DivcoWest

42	EXTERIOR DESIGN HIGH-DENSITY FIBER CEMENT RAIN SCREEN PANEL	93	NORTHPOINT DESIGN GUIDELINE CHECKLIST
43	EXTERIOR DESIGN CMU BASE UNDER FIBER CEMENT PANELS	99	CAMBRIDGE ZONING ORDINANCE CHECKLIST
44	EXTERIOR DESIGN MATERIALS	106	PROJECT DESCRIPTION FOR DESIGN REVIEW
45	EXTERIOR DESIGN MATERIALS	108	BUILDING DATA
46	EXTERIOR DESIGN MATERIAL SAMPLES-WEST ELEVATION	108	APPENDIX I DIMENSIONAL FORM
47	EXTERIOR DESIGN MATERIAL SAMPLES-WEST ELEVATION	109	APPENDIX A ACOUSTIC COMPLIANCE
48	EXTERIOR DESIGN MATERIAL SAMPLES-NORTH ELEVATION	110	APPENDIX B WIND STUDY
49	EXTERIOR DESIGN MATERIAL SAMPLES-EAST AND SOUTH ELEVATIONS	121	APPENDIX C EAST STREET CROSSWALK MEMORANDUM
50	EXTERIOR DESIGN MATERIAL SAMPLE COMPOSITE	122	CAMBRIDGE CDD COMMENT & RESPONSE-MEETING #1
51	LANDSCAPE PROGRAM AND AMENITY DIAGRAM	126	CAMBRIDGE CDD COMMENT & RESPONSE-MEETING #2
52	SITE PLAN (LANDSCAPE)	128	CAMBRIDGE CDD COMMENT & RESPONSE-29 MARCH 2022 EMAIL

CAMBRIDGE CROSSING

SHORT TERM BICYCLE PARKING PLAN

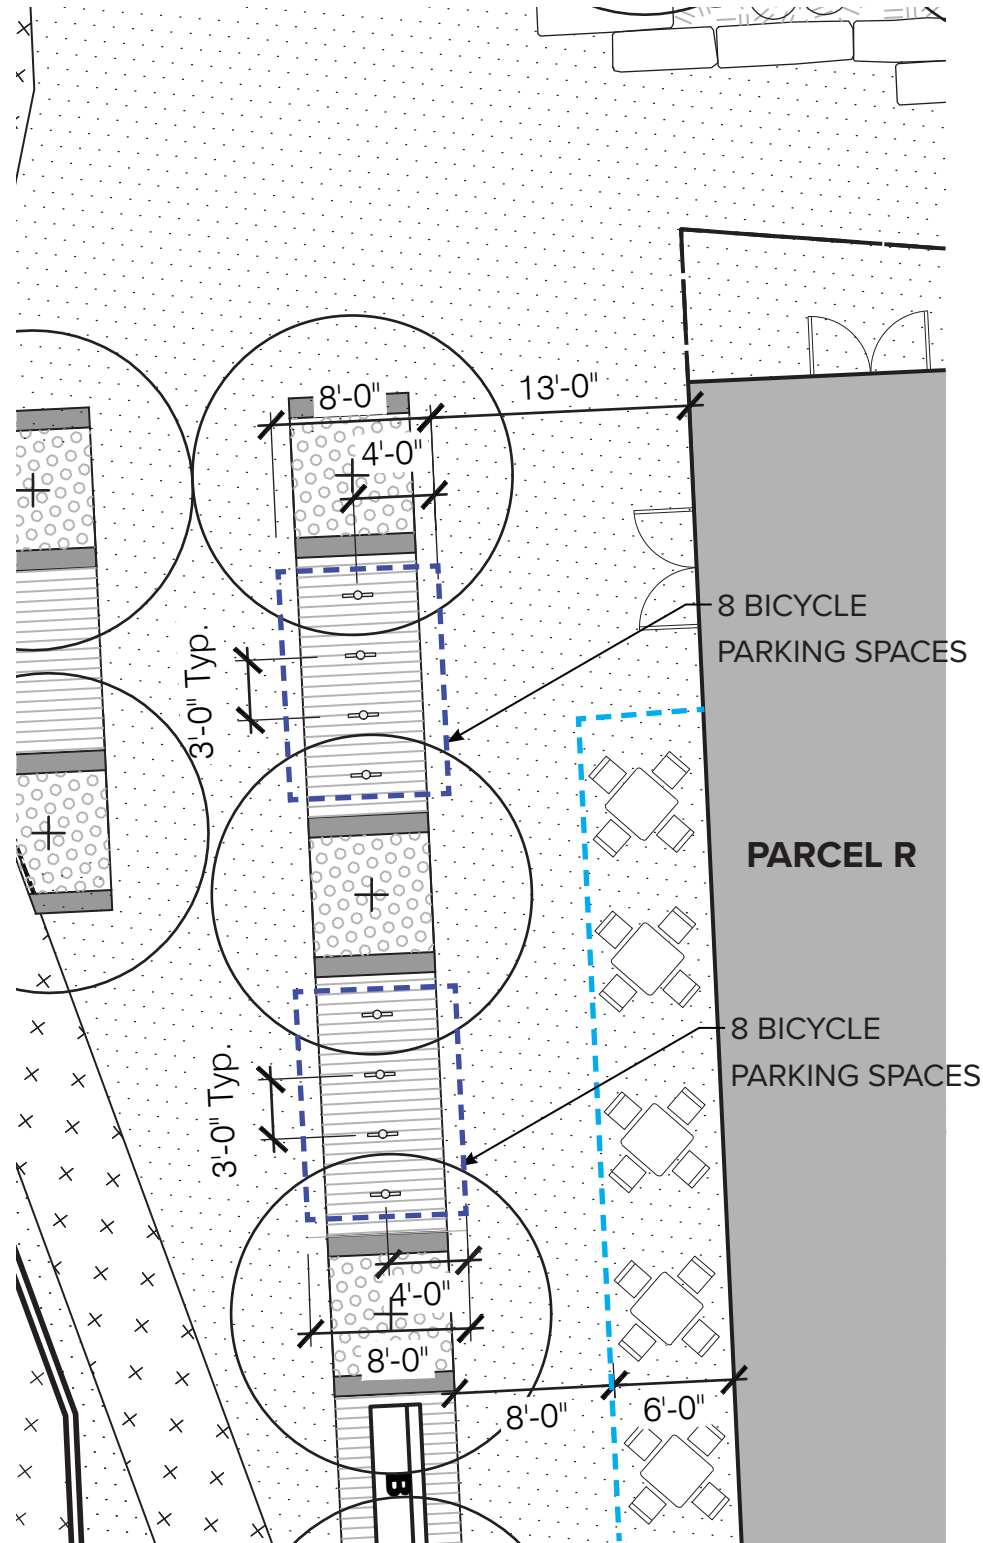
9.	There look to be some dimensional discrepancies for short term bicycle racks along North First Street.	Please see updated short term bicycle plan on page 68.

TRUCK MOVEMENT IN

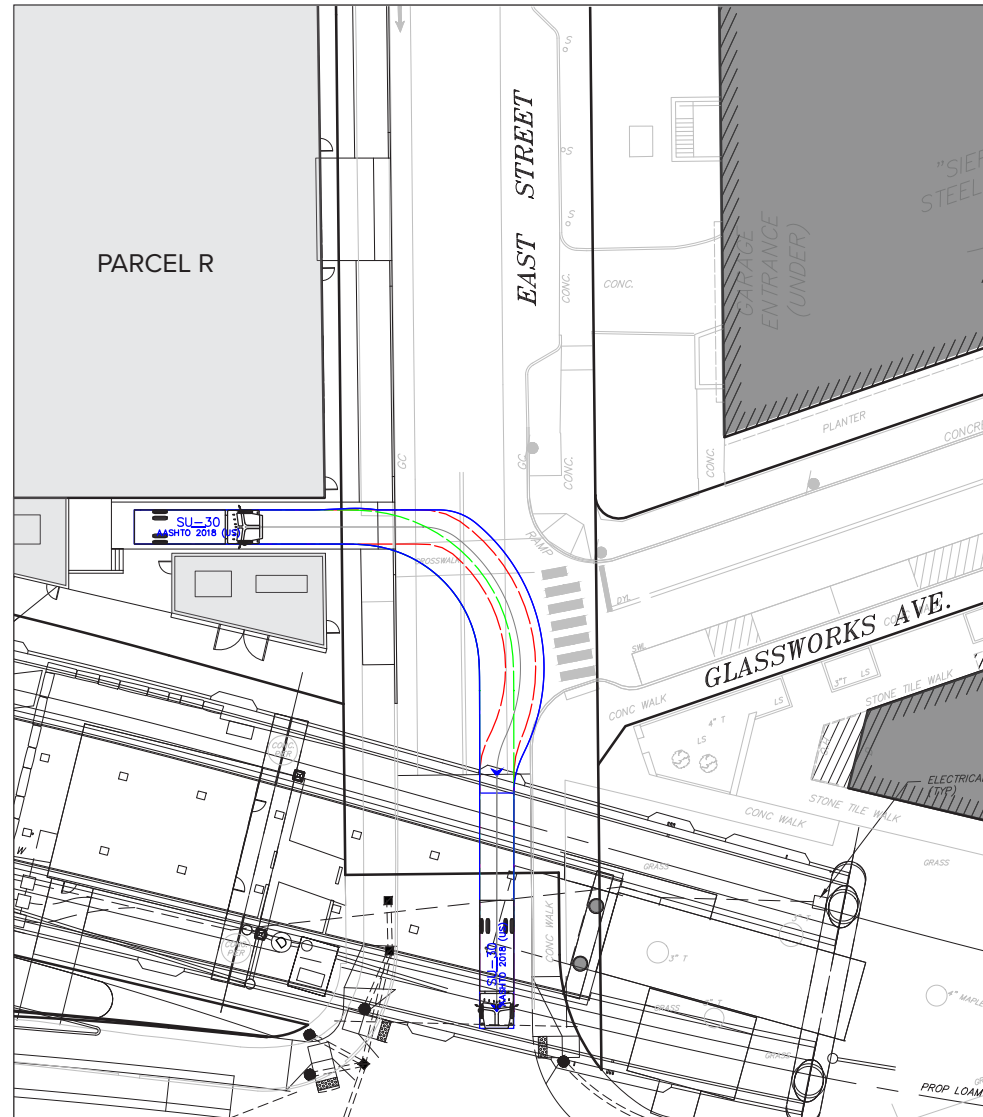
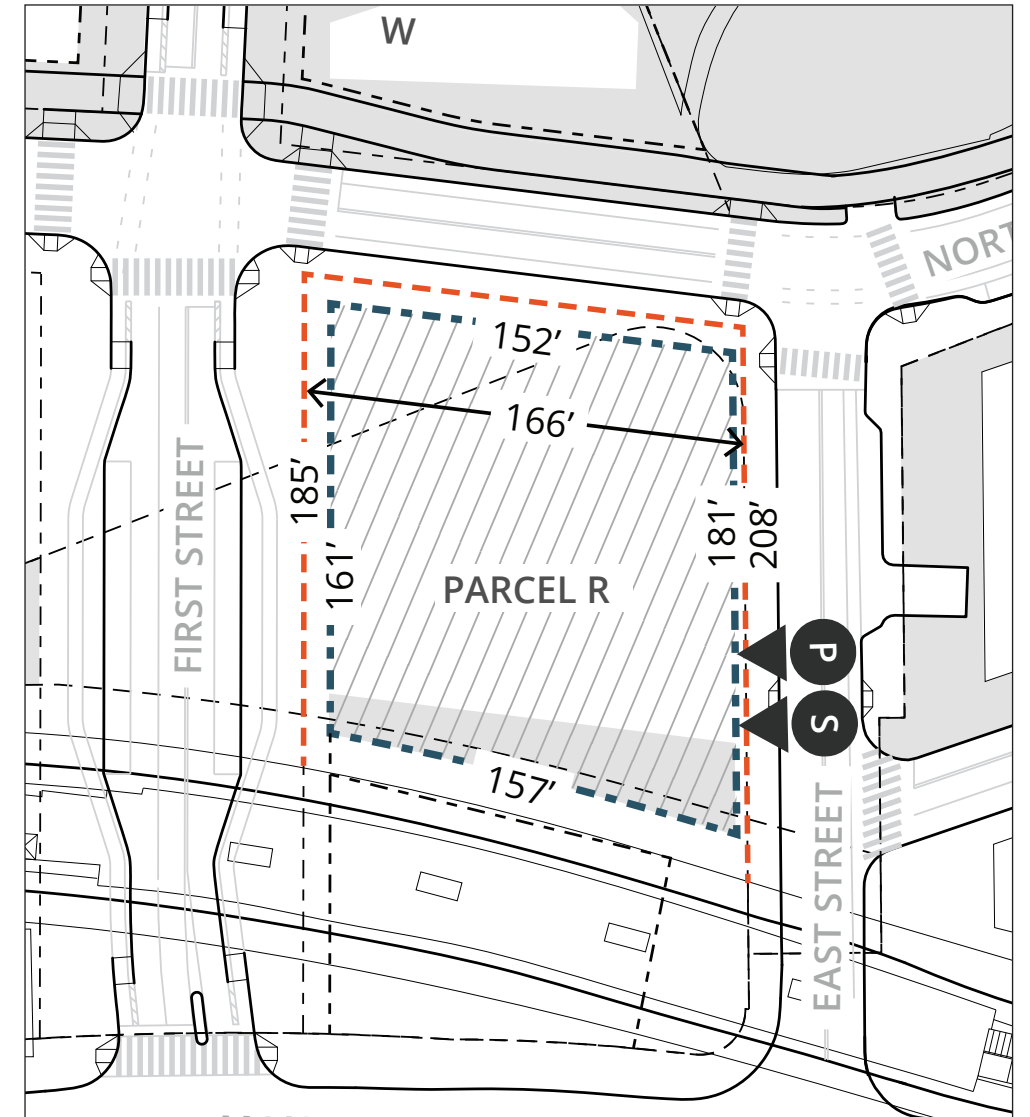
20.	Please clarify how the loading area works.	The loading area is an exterior dock outside the main volume of the building that is connected directly to the retail space. Truck turning radii are shown on page 80.

Sight Distance Analysis
 Garage and Loading Exit
 Date: 03/08/2022
 Scale: 1" = 20'
 B+T Drawing No. 208490D123C-001
 B+T Project No. 2084.90

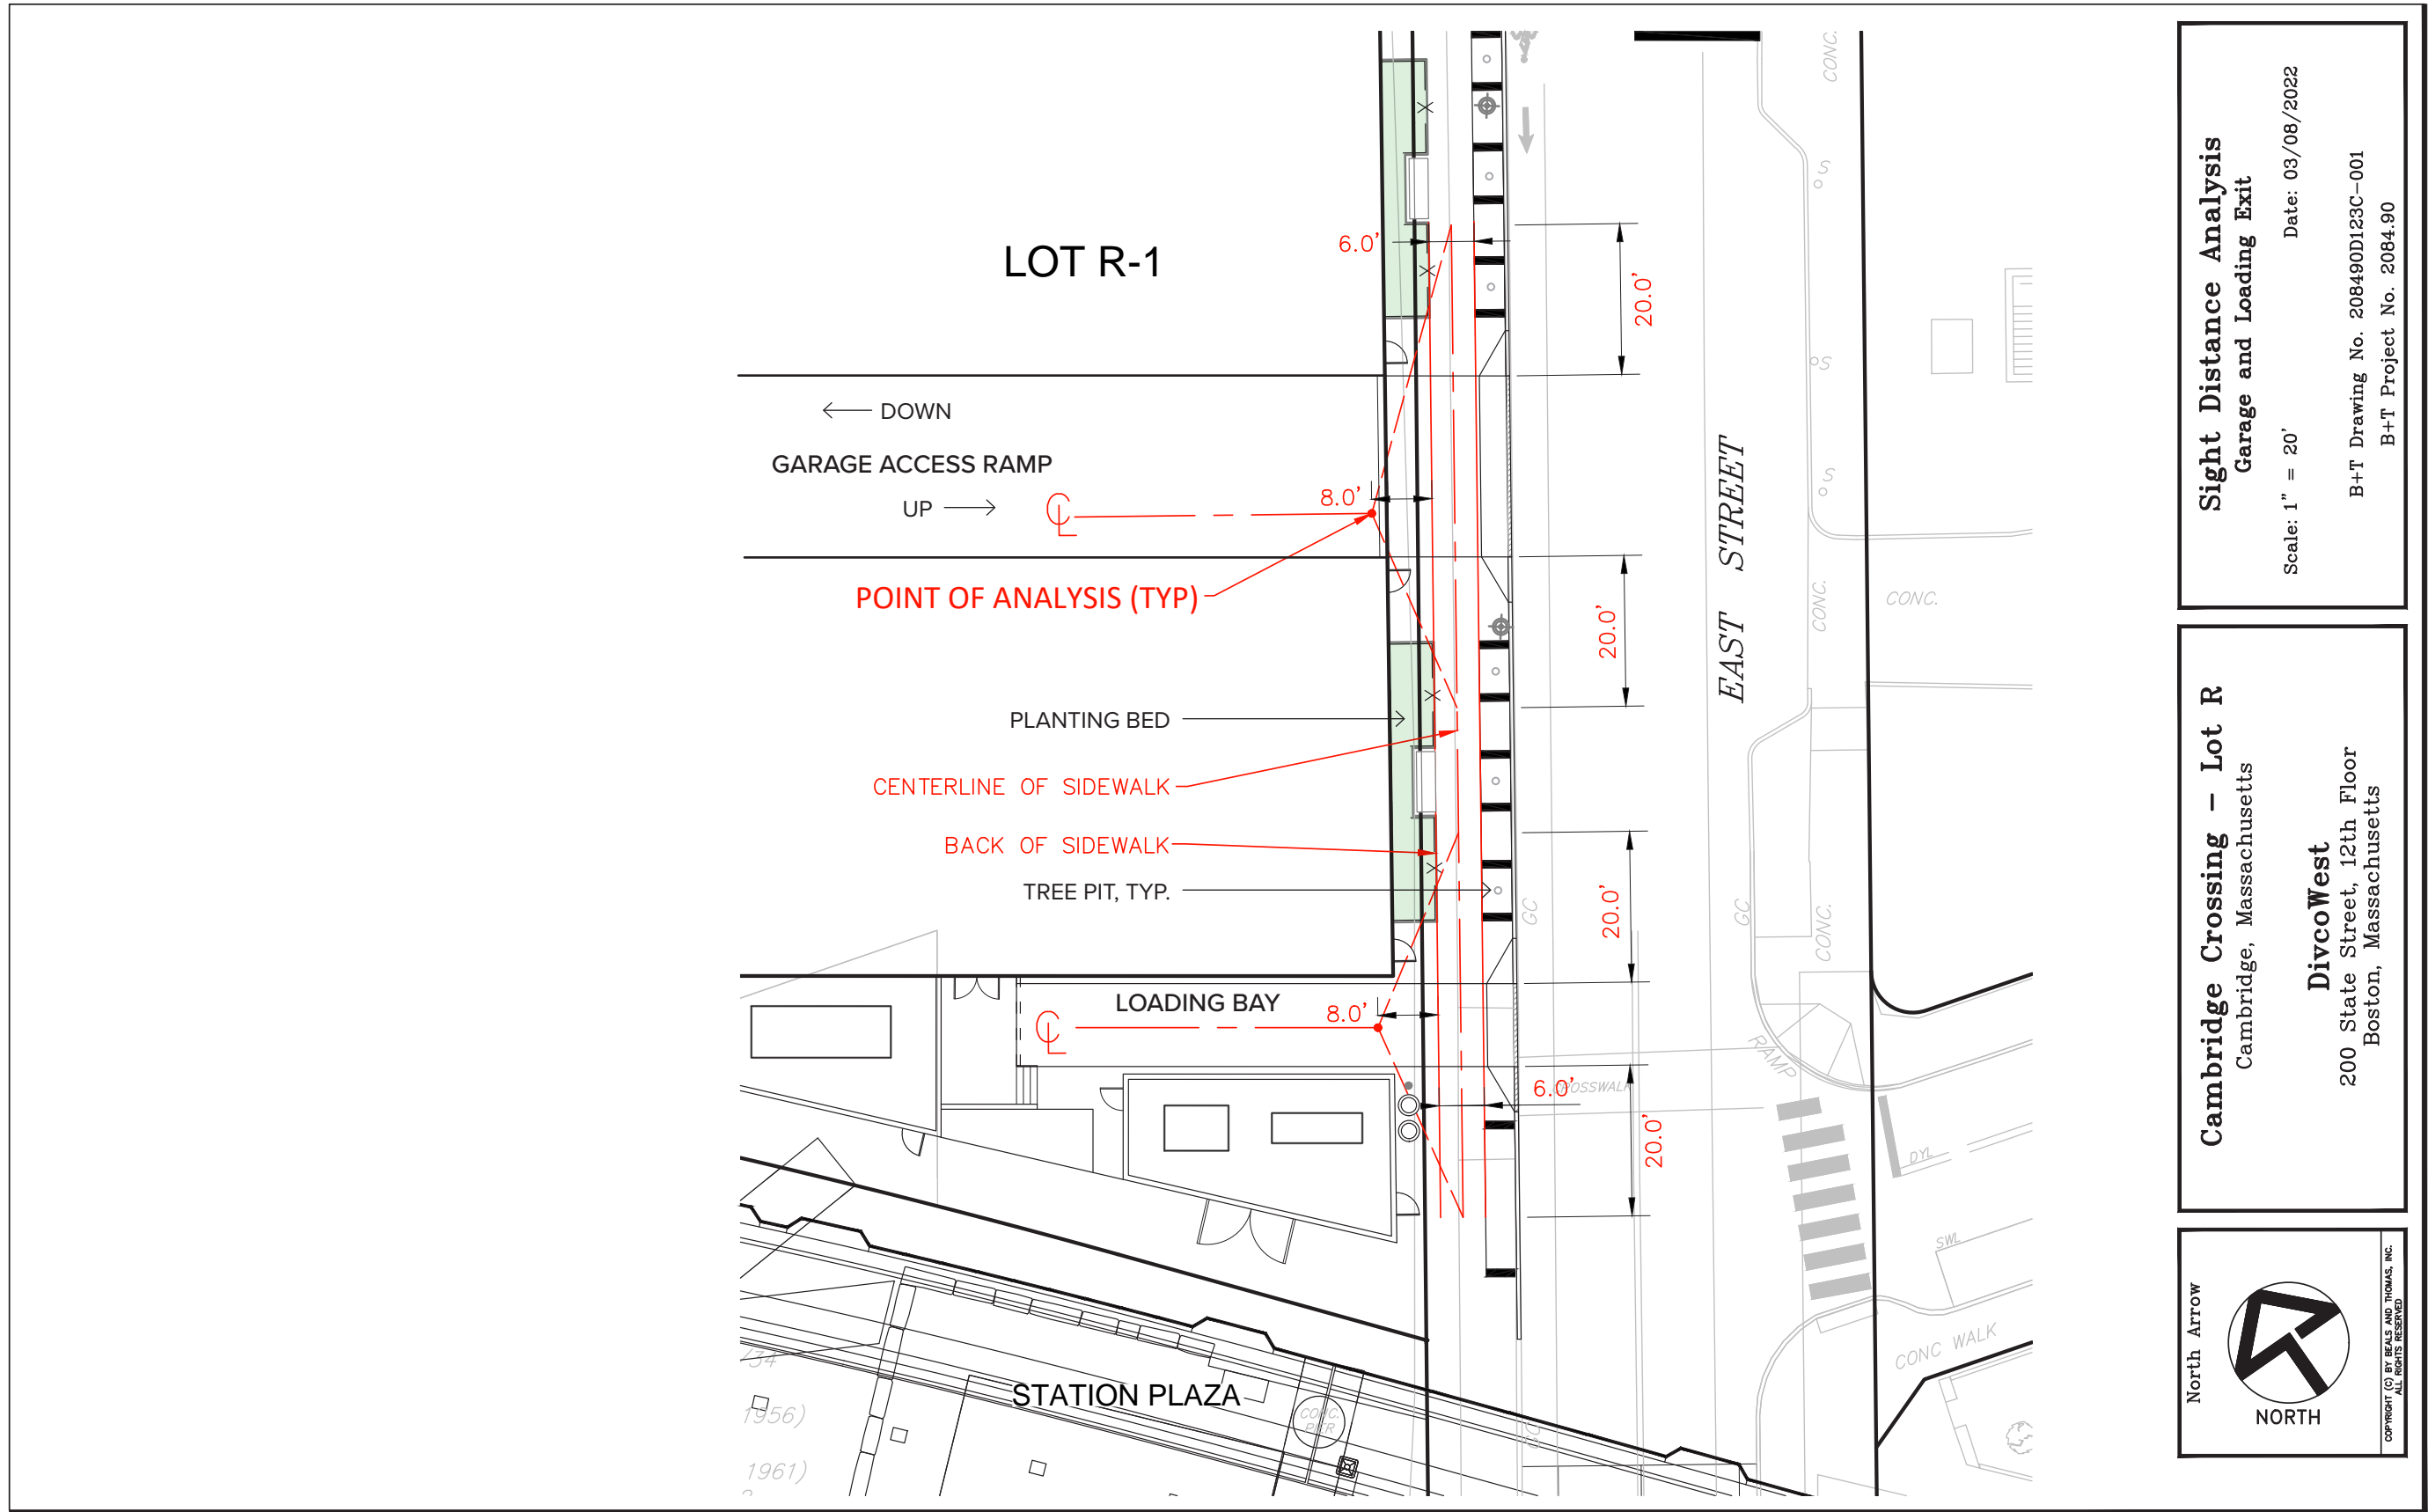
19.	Garage vehicular entrance and loading dock look well hidden. Please provide details on sight lines.	Please see sight line analysis diagram on page 81.
